Town of Windham

MEMO

RE: 17-24 519 Roosevelt Trail Condos – Sketch Subdivision Plan
Planning Board Meeting: December 11, 2017

Aerial View of the subject parcel relative to surrounding properties and street network.

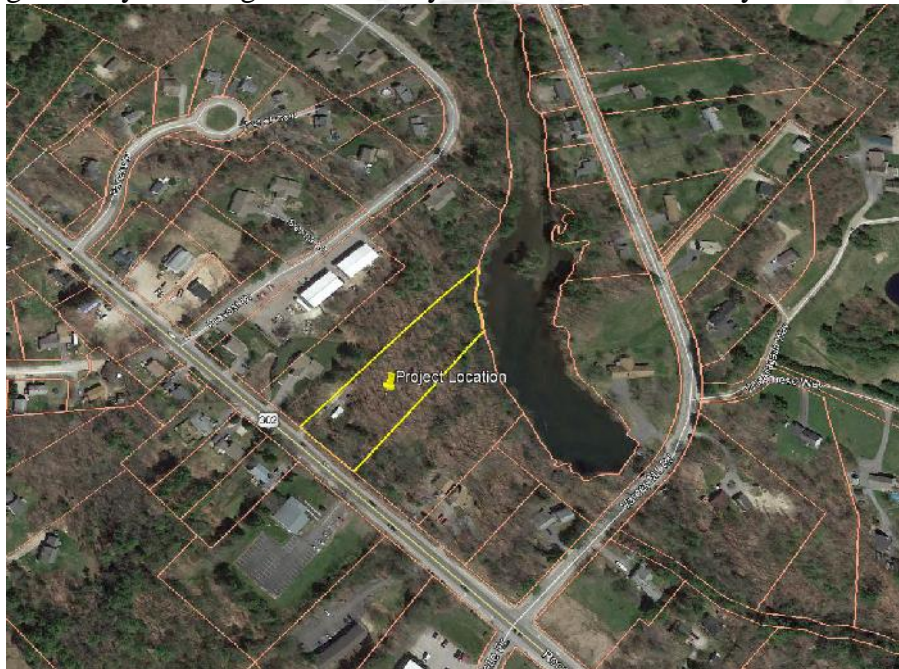
The applicant is proposing a 5 unit single family condominium development on a 2.16 acre property located at 519 Roosevelt Trail. The property has frontage on the impoundment of Ditch Brook. A single family dwelling and accessory structures were recently demolished.
